# **Proposal for a Modification of the Lower/Upper Legform to Bumper Test Area in GTR9-PH 2 and UN-R 127 01 Series of Amendments**

**6<sup>th</sup> Meeting of Task Force Bumper Test Area (TF-BTA)  
Paris, May 15<sup>th</sup>, 2014**

Bundesanstalt für Straßenwesen

- In the end, two proposals are made by Industry and the European Commission:
- Proposal 1 (TF-BTA-6-03):

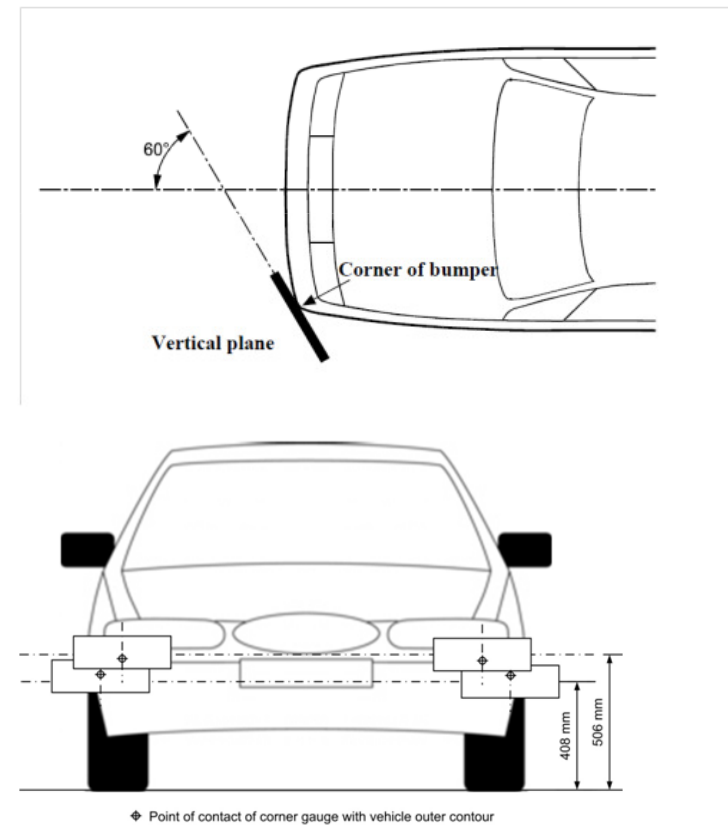
3. The bumper definition according to the US Bumper Standard / Proposal 1 (TF-BTA-6-03) does not always cover the entire bumper beam.
  4. The bumper definition according to the US Bumper Standard / Proposal 1 (TF-BTA-6-03) remains not being robust against any vehicle (outer) design measures.

4. **Injurious points have been continuously found outside test areas defined by measurements depending on the outer contour, especially at the ends of the bumper beam.**
5. **Therefore, at least the entire bumper beam should be included within the test area.**
6. **Procedures based on the outer vehicle contour do not necessarily include the relevant injurious vehicle structures (bumper beam).**
7. **There is no evidence for the RCAR definition of the bumper beam not being robust also for legislation.**

**3.10 The bumper test area is defined as either the area limited by the bumper corners or the outermost ends of the bumper beam/lower rails/cross beam structures, whichever is larger.**

**3.13 The corner of bumper is the point of contact of the vehicle with a vertical plane which makes an angle of  $60^\circ$  with the vertical longitudinal plane of the car and is tangential to the outer surface of the bumper, see Figure 5. Where multiple or continuous contacts occur the most outboard contact shall form the bumper corner.**

**3.30 The bumper beam is defined as the structural cross member under the bumper fascia protecting the front of the vehicle. The beam does not include foam, cover support or any pedestrian protection devices.**

- Proposal 2 (TF-BTA-6-04):

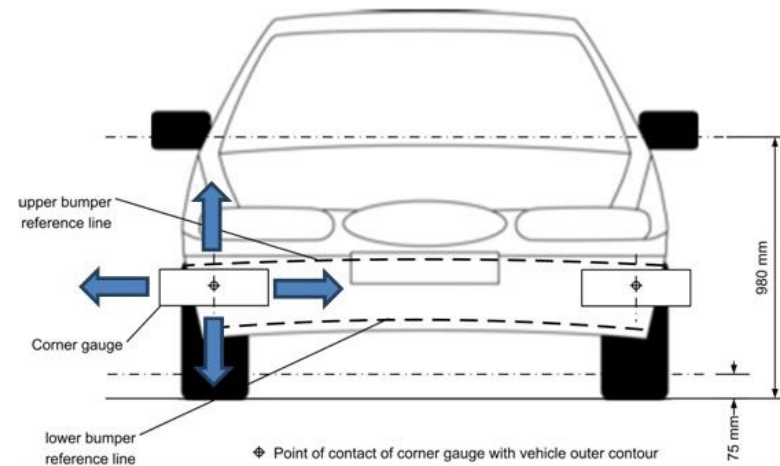
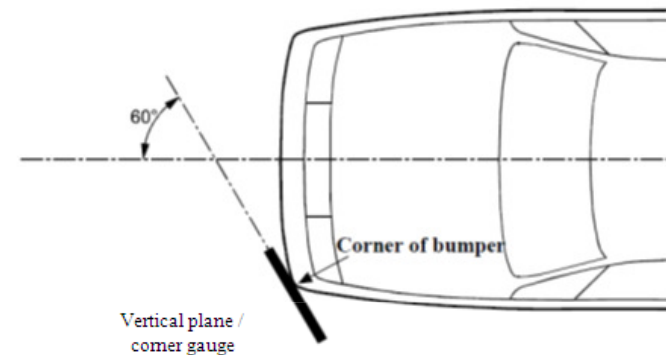
## 2. Proposal 2 (TF-BTA-6-04) does not work:

As the lateral limitations of the upper (and lower) bumper reference lines as defined in sections 3.27 and 3.21 of UN-GTR 9 are implied by the bumper corners, latter ones cannot be defined by any means like maximum (minimum) values of the mentioned references lines.

Maximum of UBRL ?

Minimum of LBRL ?

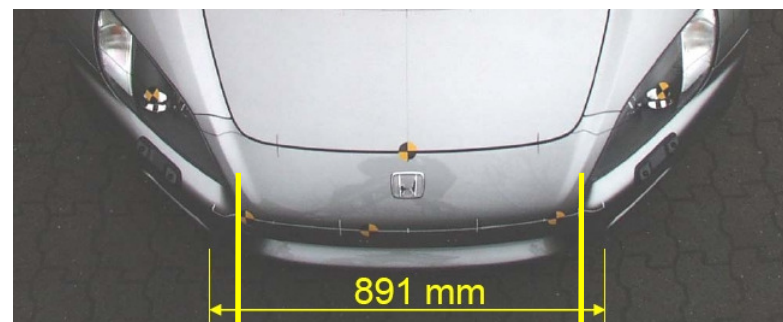
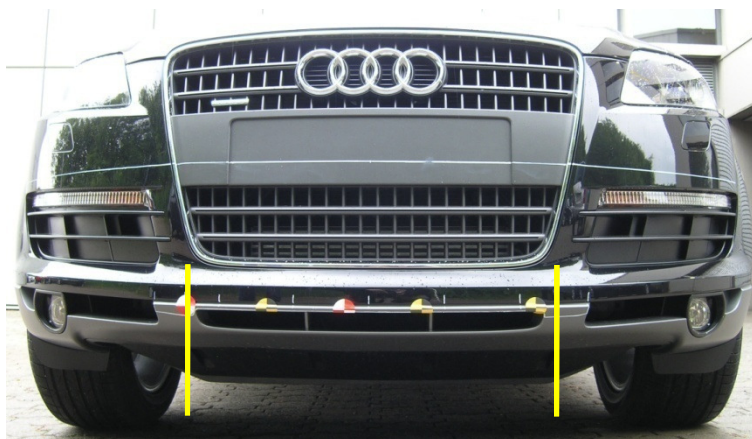
3. The bumper definition according to the US Bumper Standard / Proposal 1 (TF-BTA-6-03) does not always cover the entire bumper beam:
